STAFF REPORT: 08/14/2024 REGULAR MEETING

APPLICATION NUMBER: HDC2024-00354

ADDRESS: 14846 ASHTON

SCOPE: DEMOLISH GARAGE AND ERECT GARAGE

Figure 1, Sanborn vol 26, 1938-1950: showing garage presence of garage and house (red outline) at time of widening of Southfield Rd.

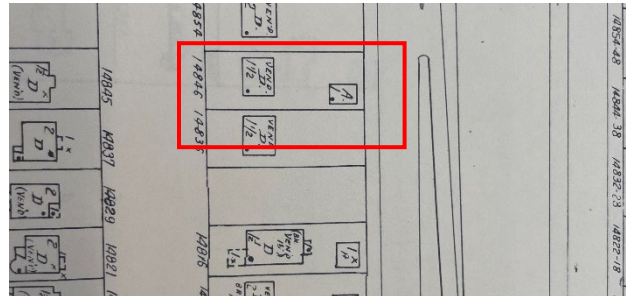
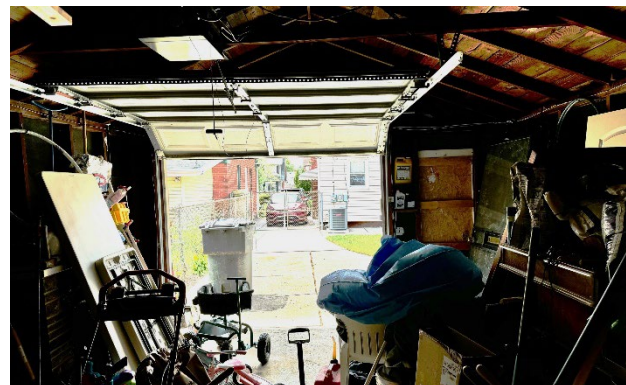
- Despite the lean and easement conflict, staff has the opinion that the presence of the garage likely predates the easement, which is not grounds for dismantling the structure. (The Southfield Freeway was constructed in 1959, 10 years after the construction of the house. Staff was not able to identify the precise construction date of the garage but assesses that its construction is likely close to the construction of the house in 1949. *See figures 1-2*)

Figures 1&2, by Applicant: showing proposed front and side elevations of the garage.

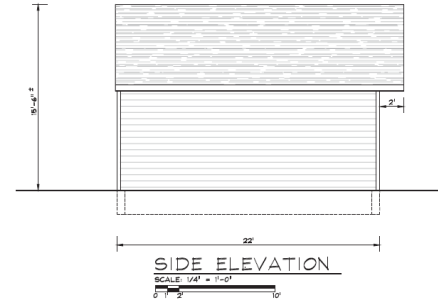
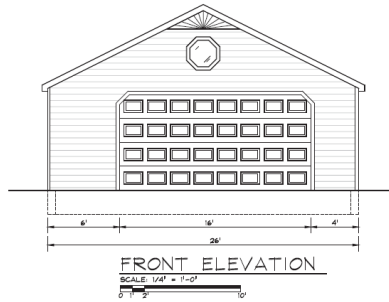
- Staff has the opinion that the proposed height and scale of the new garage goes beyond an appropriate size that is deferential to the primary structure, i.e., the house. Also, the proposed octagonal window at the front gable introduces a new element that is not appropriate nor relates to the primary structure. It is staff's opinion that the proposed height, scale and window design for this garage are inappropriate as they do not meet the Elements of Design nor "relate to the main dwelling". Staff opines that a lower pitch roof and a smaller footprint with a simple front gable design would be an appropriate alternative should the Commission decide that the construction of a new garage is appropriate.

- Staff offers the opinion that the scale of the garage, particularly it’s width, height, and material use of vinyl siding and introduction of an octagonal window is demonstrably inappropriate because it does not relate with the house nor follows the Elements of Design, where “Garages, when original, often correspond in materials to the main body of the dwelling, but are of modest, one-story, simple box design with single- or double-doors.”

Figure 3, by Applicant: proposed site plan showing garage, driveway and rear patio locations.

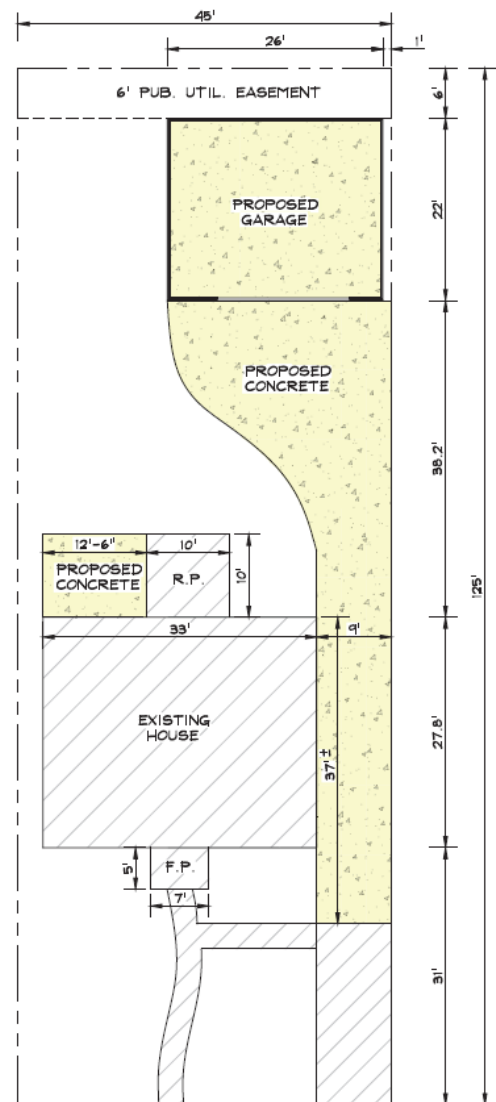
- Staff has no issue with the proposed concrete patio. (See Fig 3 and Site Photo 4.)
- It is staff's opinion that the proposed driveway either match the dimensions of the existing drive, or at a width that matches a reduced scaled garage should the Commission approve a new garage.

- The driveway is replaced within its current footprint.
